Department of Energy
 Carlsbad Field Office
 P. O. Box 3090
 Carlsbad, New Mexico 88221

Subject: Response to Environmental Protection Agency Letter Dated May 21, 2009 Regarding Compliance Recertification Application

EPA Comment**1-23-1 New Compliant Performance Assessment**

Figure 1. Fraction of initial CPR remaining in the repository as a function of time for the undisturbed scenario, replicate R1.

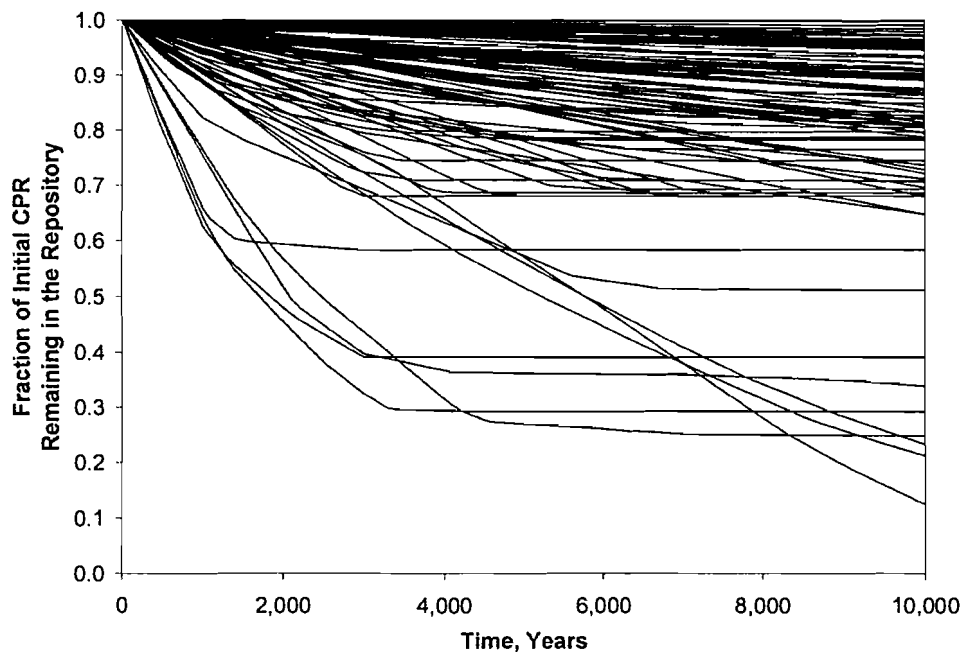
Appendix PA-2009, Section 7.1.1 attributes slower changes in repository pressure after 2,000 years to cessation of room closure, slowing of brine inflow, and consumption of CPR. DOE should provide information regarding whether the slower rates of microbial degradation assumed for the CRA-2004 PABC and the CRA-2009 PA result in the persistence of CPR for longer than 2,000 years in most realizations.

One of the many things that can affect the repository pressure is CPR degradation. Gas generation is dominated by iron corrosion. For the undisturbed scenario, on average three times the amount of gas is generated from iron corrosion compared with CPR degradation (see Section 6.3.5.3 and Table 6-9 in Nemer and Clayton 2008). Figure 1 displays the fraction of the initial CPR remaining in the repository for the undisturbed scenario. CPR persists in all of the vectors for the entire 10,000 year period. Although the CPR persists at times longer than 2,000 years, the degradation of the CPR is minimal for many vectors at longer times.
